GROUP ENG	MODEL 2018MY Stinger (CK) 2.0T
	NUMBER 191 (Rev 2, 02/20/2019)	DATE November 2018
TECHNICAL SERVICE BULLETIN		
SUBJECT: SERVICE ACTION: 2.0T ECU REPLACEMENT FOR DTC P053F AND/OR P0087 (SA352)

This bulletin provides the procedure to replace the Electronic Control Unit (ECU) on ALL 2018MY Stinger (CK) 2.0T vehicles, produced from September 29, 2017 through March 27, 2018, which may exhibit engine hesitation and/or a Malfunction Indicator Light (MIL) ON with DTCs P053F and/or P0087 as the engine is warming up to operating temperature. Follow the procedure below to replace the ECU. Before conducting the procedure, verify that the vehicle is included in the list of affected VINs.

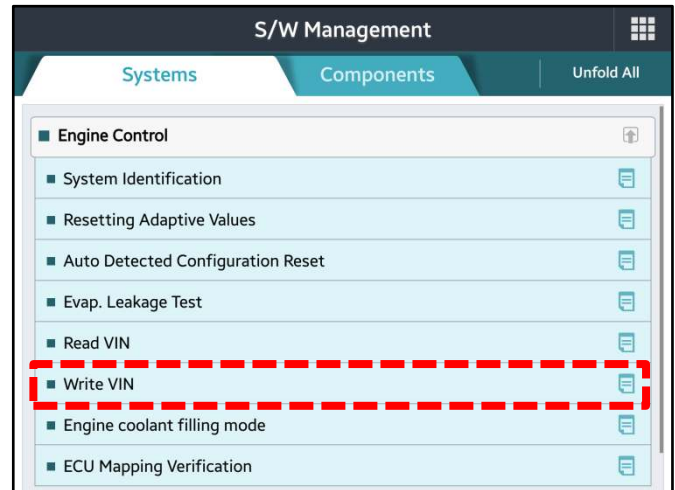
1. Replace the ECU by referring to the “Engine Control/Fuel System → Engine Control System → Engine Control Module (ECM) → Repair procedures” chapter in the applicable Shop Manual on KGIS.

2. Using a KDS, perform VIN writing for the new ECU.
